Parking Scheme, Marden Road, Whitley Bay  
Road Safety Assessment  
North Tyneside Council

May 2012

# Appendix A Key Plan

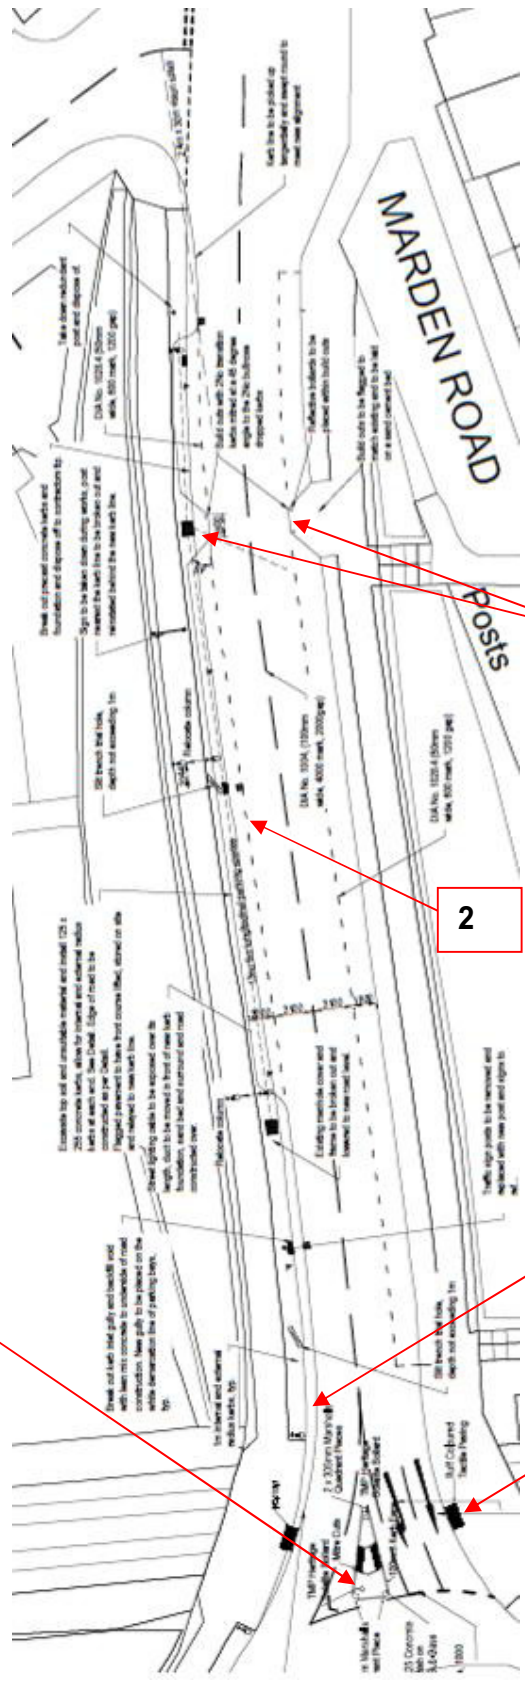
Ref	Location	Issue	Recommendation
1	Marden Road (southern end) 	Dropped kerbs/tactile paving exist on the east side of Marden Road. However, no facility is provided on the west side (appears to have been removed as part of the works). This may result in conflicts for vulnerable road users.	Remove dropped crossing and tactile paving.
2	Marden Road (west side) 	Double yellow lines still remain adjacent to the parking area provided on the west side of Marden Road. The provision of a parking area and also double yellow lines may result in driver confusion and lead to conflicts. The Assessment Team are unaware whether the TRO associated with the double yellow lines has been revoked.	Remove double yellow lines, amend the existing TRO and provide appropriate signs.  This can be carried out following the resurfacing (programmed for 2 July 2012).
3	Marden Road 	Previous centre line road marking is still clearly visible. This may result in drivers passing too close to each other and lead to collisions.	Remove redundant centre line road marking.  This can be carried out following the resurfacing (programmed for 2 July 2012).

<p>4</p>	<p>Marden Road (both sides)</p> 	<p>The parking bays have been constructed without a tapered entry/exit (virtually perpendicular to the main carriageway) with individual bays not marked out. This may lead to the following and subsequent conflicts:</p> <ul style="list-style-type: none"> <li>• Vehicles protruding into carriageway;</li> <li>• Sudden braking to enter parking area (particularly just after leaving roundabout); and</li> <li>• Several manoeuvres to enter/egress parking (including reversing and crossing into the opposing carriageway).</li> </ul> <p>In addition, there may be future maintenance issues in trying to sweep the bays and the removal of detritus leading to potential drainage issues.</p> <p>The lack of formal markings of the parking bays may also lead to reduced parking efficiency.</p>	<p>Provide either a kerbed or painted parking bay tapers.</p> <p>Mark out individual bays to ensure parking is controlled and formalised.</p> <p>This can be carried out following the resurfacing (programmed for 2 July 2012).</p>

<p>5</p>	<p>Marden Road (both sides)</p> 	<p>Build-outs have been provided within the parking areas on both sides of the carriageway. It is unclear whether these have been provided for pedestrians. During the site visit, the build-outs were regularly used as a crossing point and appear to be within pedestrian desire line. The close surrounding parking and design of the build-outs restricts visibility between pedestrians and vehicles.</p> <p>The build-outs have dropped kerbs but no tactile paving has been provided to assist partially sighted pedestrians. In addition, the bollards provided on the build-outs create a partial obstruction for visually impaired, mobility scooters, wheel chair and pushchair users.</p> <p>The gradients also appear excessive. This may result in pedestrian slips and issues for vulnerable road users, particularly during wintry weather.</p>	<p>If build-outs are for pedestrian use, ensure suitably designed.</p> <p>If build-outs are not for pedestrians, provide measures to discourage use.</p>

6	<p>Marden Road</p> 	<p>Throughout the scheme extents there are gaps between the new kerb-lines and carriageway. This may lead to carriageway deterioration as well as potential drainage issues.</p>	<p>Remove gaps between carriageway and kerbs.</p> <p>This can be carried out during the resurfacing (programmed for 2 July 2012).</p>
7	<p>A191/A193 roundabout</p> 	<p>Gaps exist between the tactile paving and surrounding footway on east side of crossing point (at new splitter island). This may result in trip and falls for pedestrians, particularly for those with heeled footwear.</p>	<p>Remove gaps between tactile paving and surrounding footway.</p>
8	<p>A191/A193 roundabout</p> 	<p>There is a 'Keep left' sign located on the exit from the roundabout onto Marden Road. Traffic can pass to the right of the sign therefore sign incorrect and misleading.</p>	<p>Replace with a plain faced flexible bollard.</p>

9	<p>Marden Road</p>	<p>Marden Road is a busy distributor road within a 20mph Zone, which is also a bus route and used by HGVs. The narrowing of the carriageway to introduce the parking area has resulted in the traffic being squeezed together. HGV/Buses were observed to encroach into the opposing lane. In addition, it has also resulted in drivers/passengers having to open their car door within the live carriageway with limited room for manoeuvre.</p> <p>It is acknowledged that due to the layout and constraints, all road users are likely to show extra care and attention. Refer also to Ref. 4.</p>	<p>Remove the verge on the eastside to widen the available carriageway width.</p> <p>This could also create opportunities for type of parking to increase capacity without impacting on road safety i.e. echelon parking.</p> <p>It is acknowledged that this may not be financially viable.</p>
